CITY OF CANTERBURY BANKSTOWN

STORMWATER SYSTEM REPORT 20 Dasea Street, CHULLORA NSW 2190

Date: 13-Mar-2020
Ref: WP-SIA-339/2020
Development type: **Industrial**

100 Year ARI Flood Extent and Flood Contour Levels (mAHD) from Rookwood Road Catchment for 20 Dasea Street, Chullora

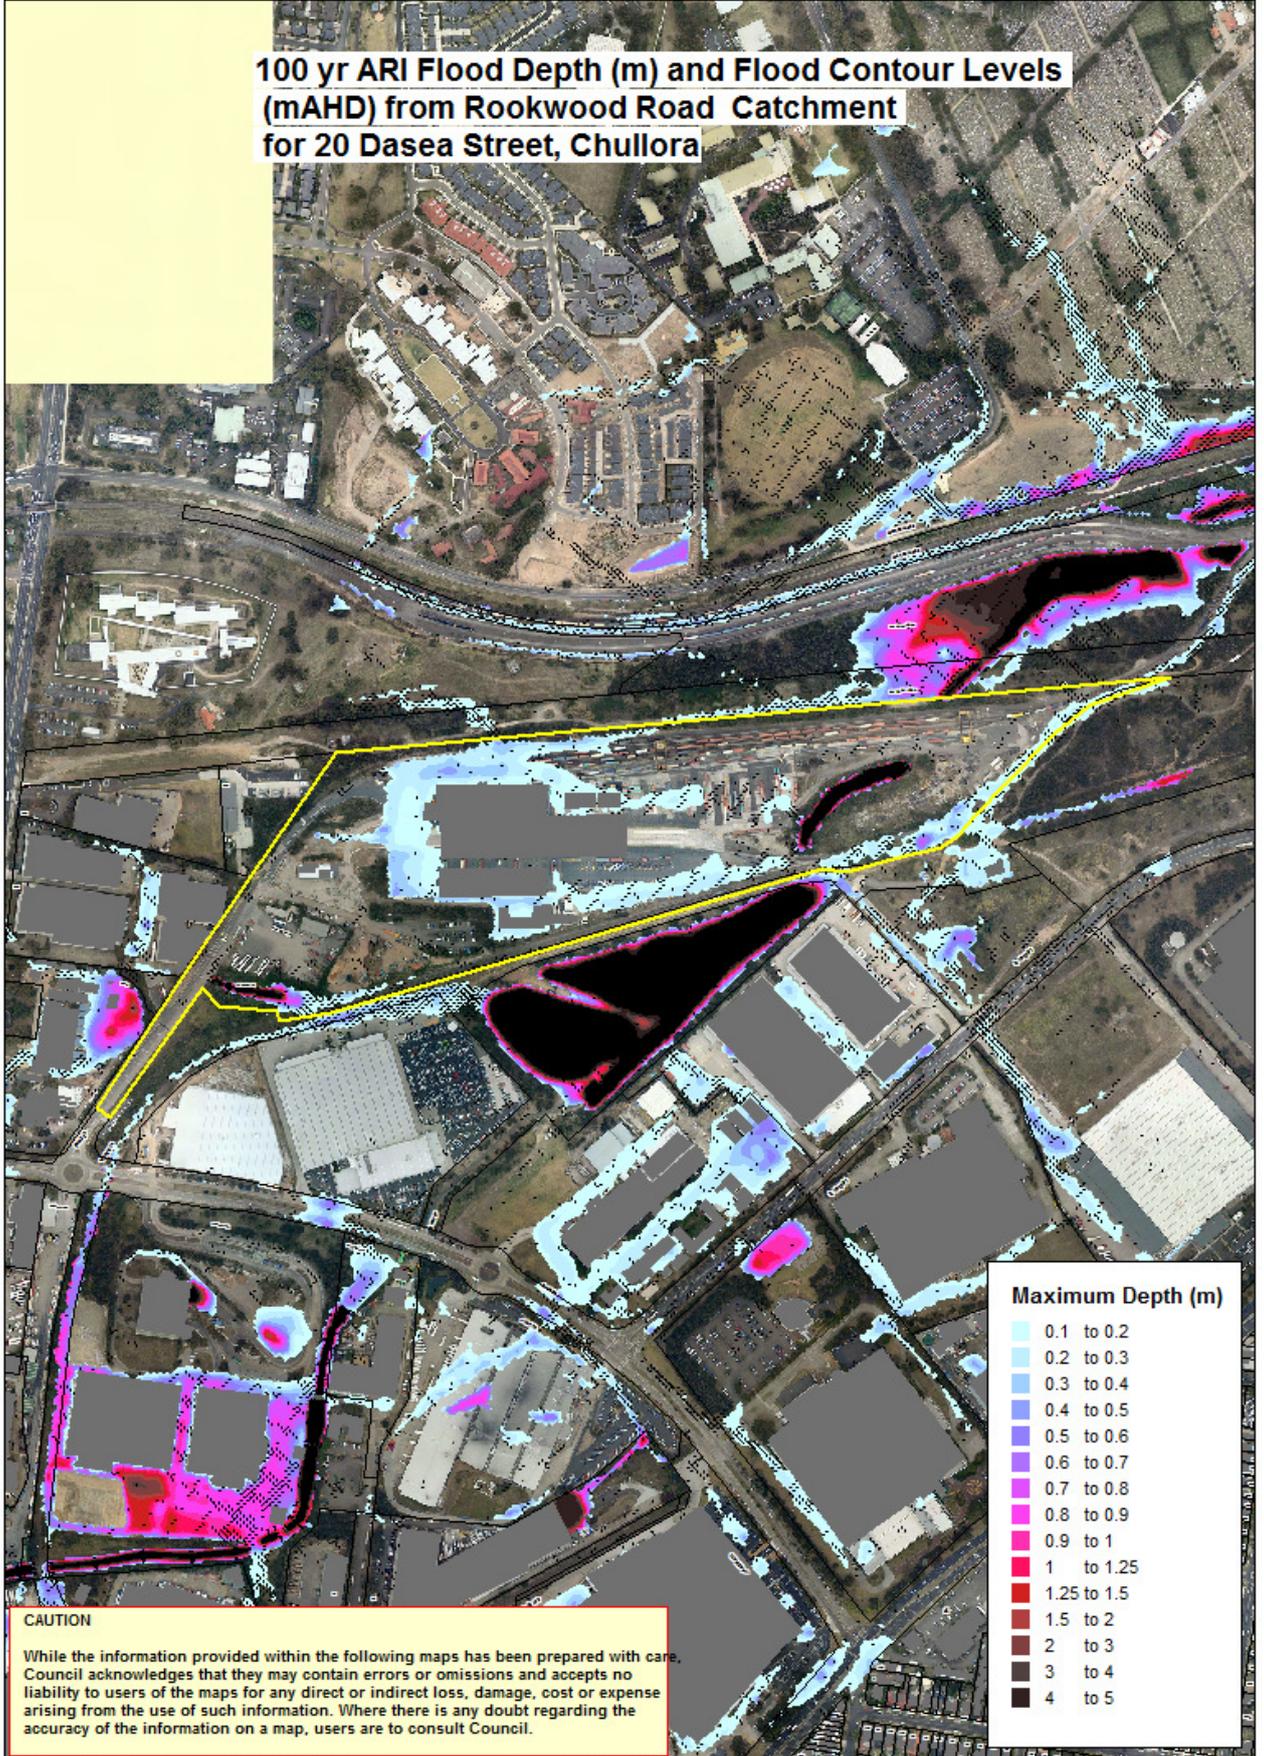
The site will be subject to stormwater inundation from this overland flowpath during large storm events. Refer to the attached "**100 Year ARI Flood Extent Maps from Rookwood Road Catchment Study**". Provision should be made on site, and at boundary fences, for this stormwater runoff to pass unobstructed over the site. Stormwater flowing naturally onto the site must not be impeded or diverted.

For this development, a flood /overland flow study to determine the 100 year ARI* water surface level is not necessary provided that:

- **The proposed development including floor levels, shall comply with the development controls specified in Part B12 Schedule 5, of Bankstown's Development Control Plan 2015 - Catchments Affected by Stormwater Flooding.**

100 Year ARI Flood Extent and Flood Contour Levels (mAHD) from Rookwood Road Catchment for 20 Dasea Street, Chullora (North east corner)

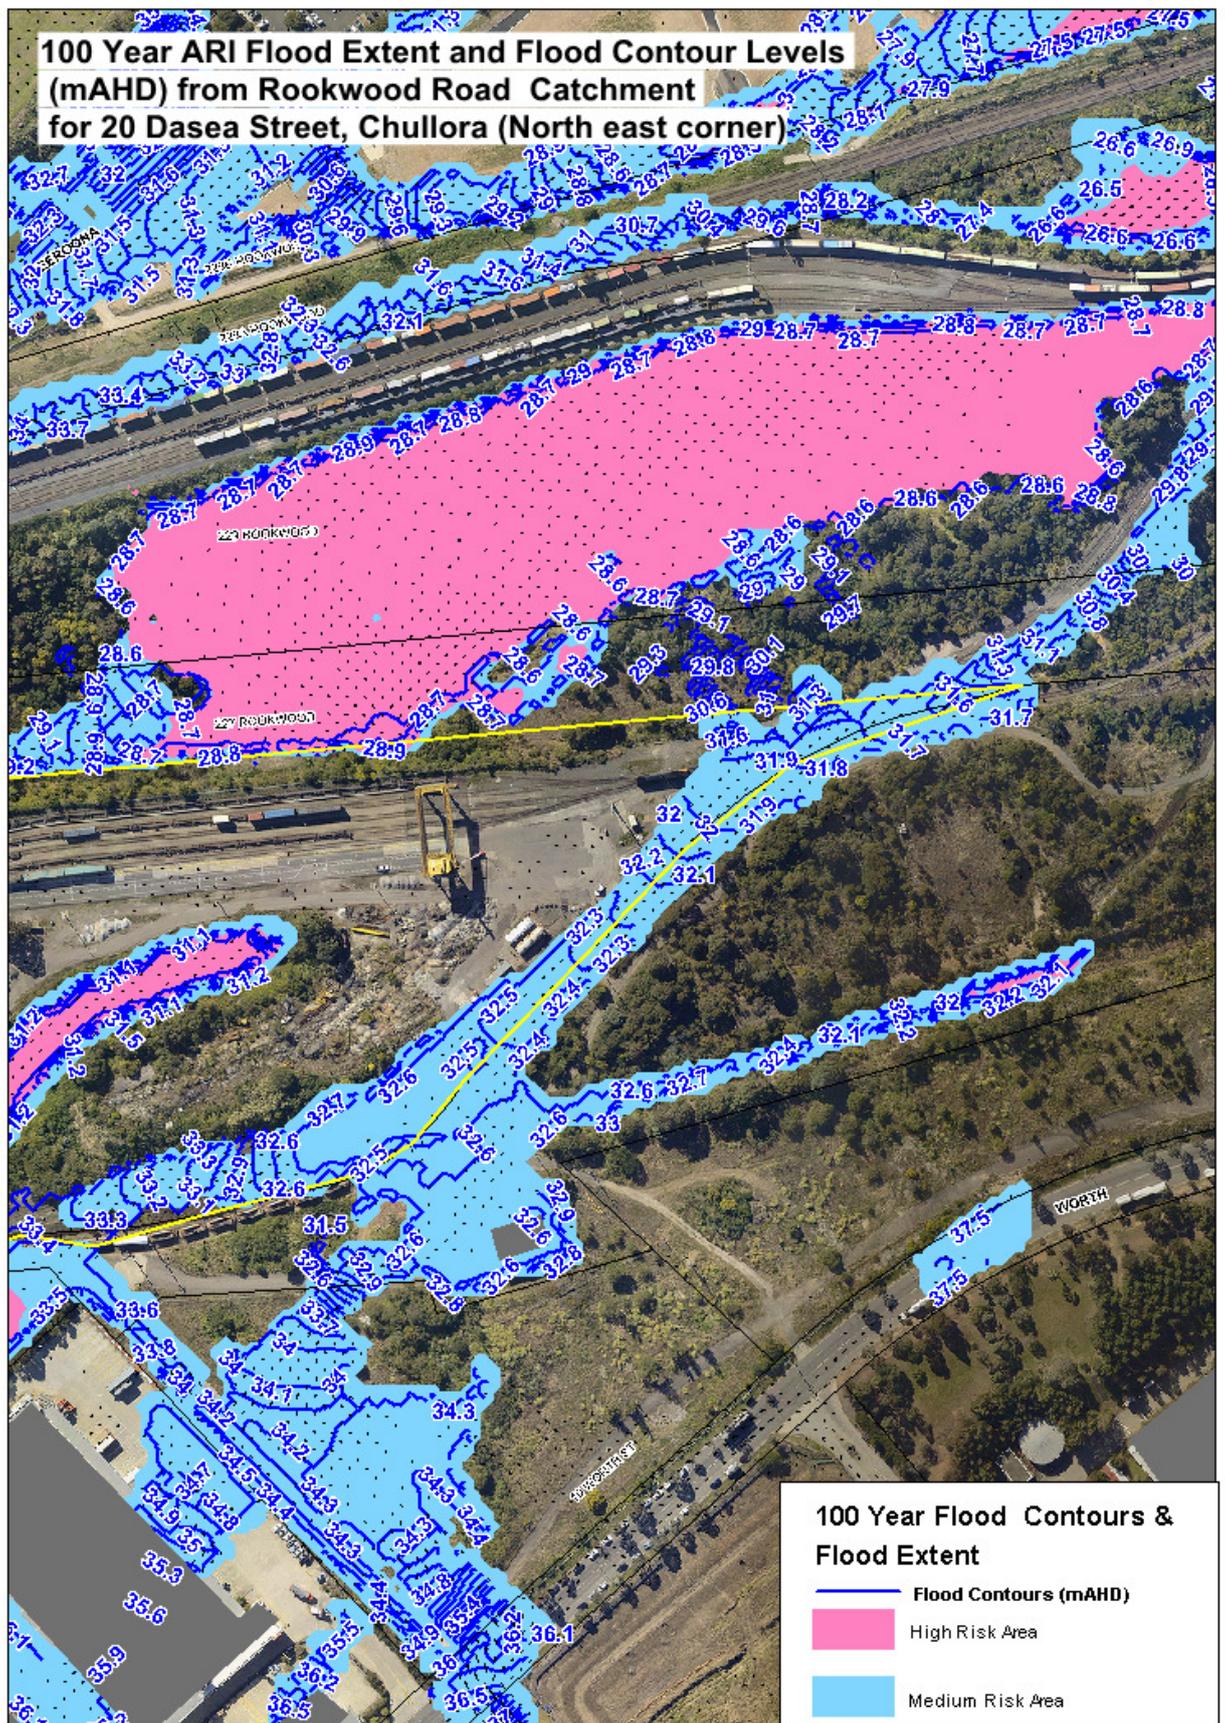
- **Provide the suitable overland flowparths to the site at south west corner, northern boundary, north east corner & eastern boundary.**

100 Year ARI Flood Extent and Flood Contour Levels (mAHD) from Rookwood Road Catchment for 20 Dasea Street, Chullora (South west corner)

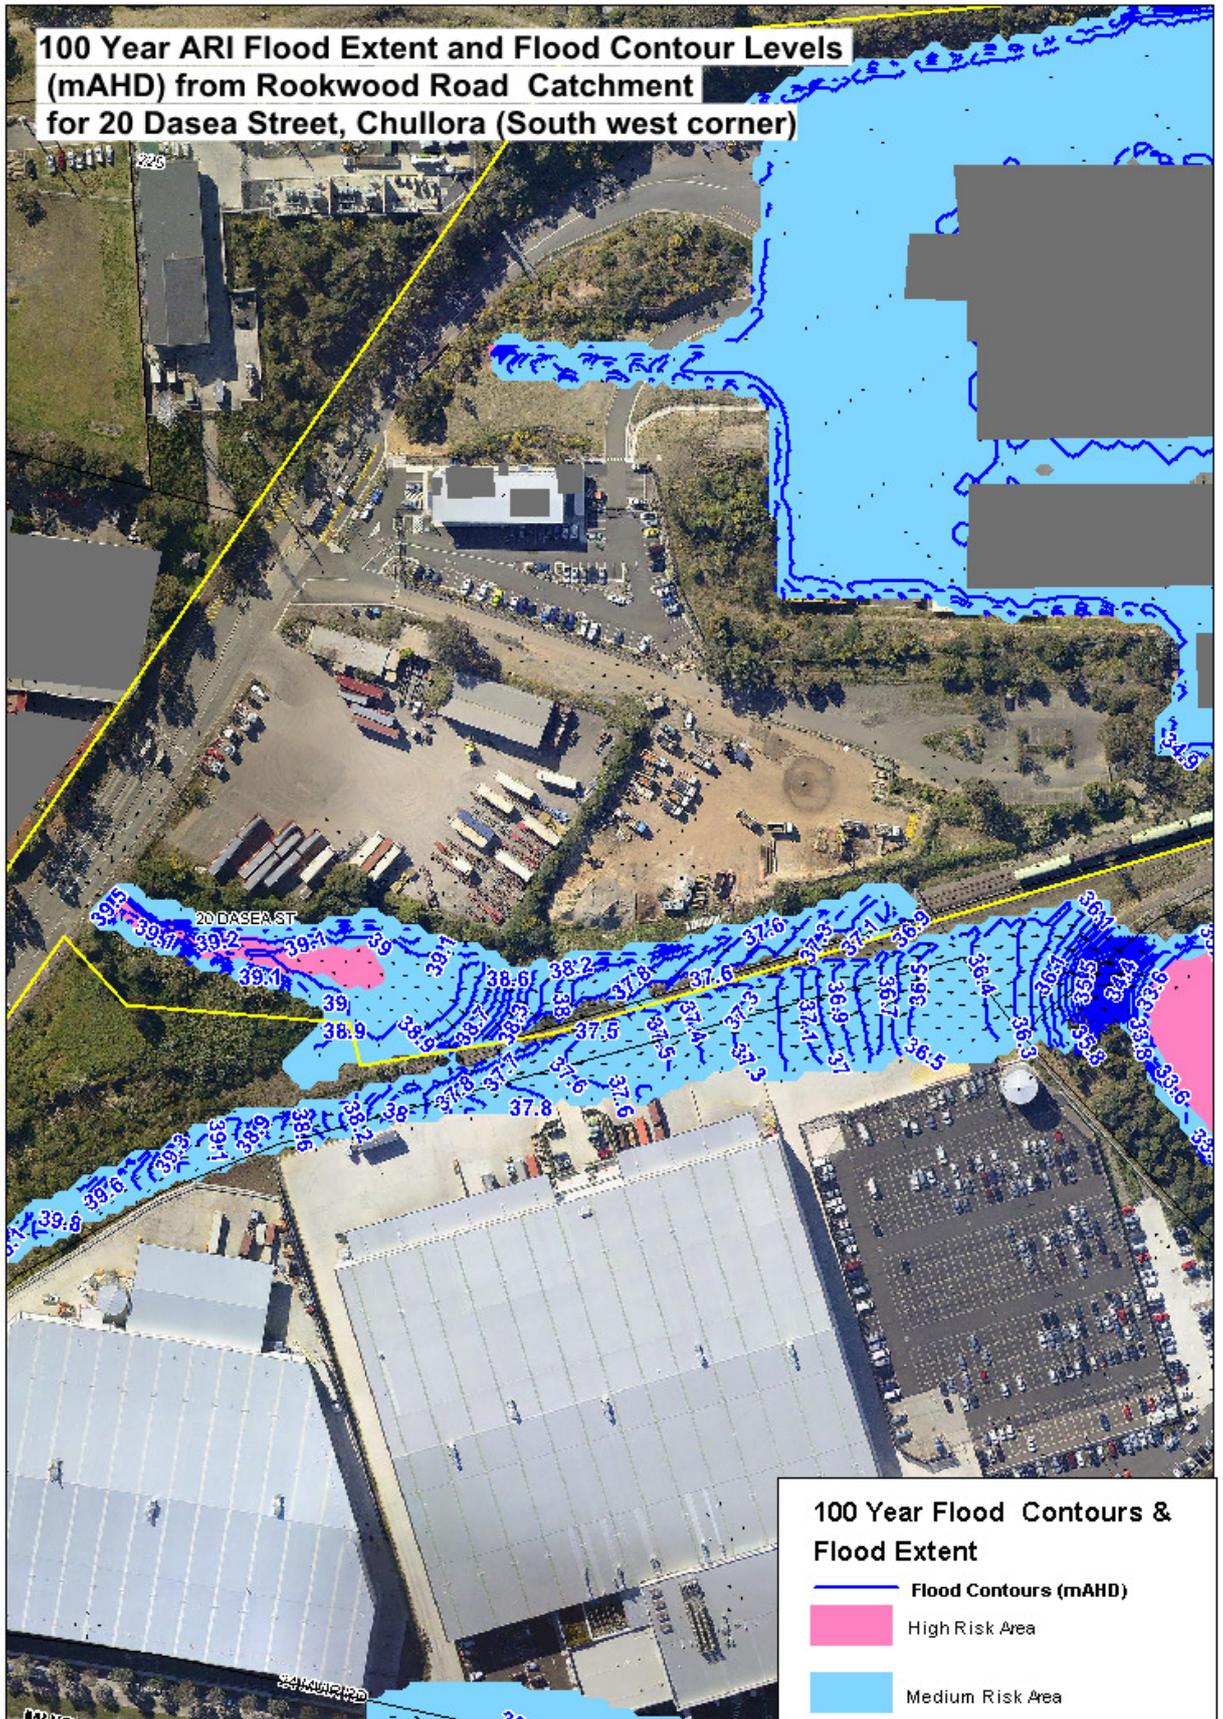
- Council's stormwater pipelines and associated 4m wide drainage easement located south west corner within the site.
- Overland flowpath for excess stormwater runoff from the upstream catchment and associated with the drainage systems located west, east & north of the site.

All structures and buildings must be located clear of pipelines and easements and overland stormwater flowpaths *.**
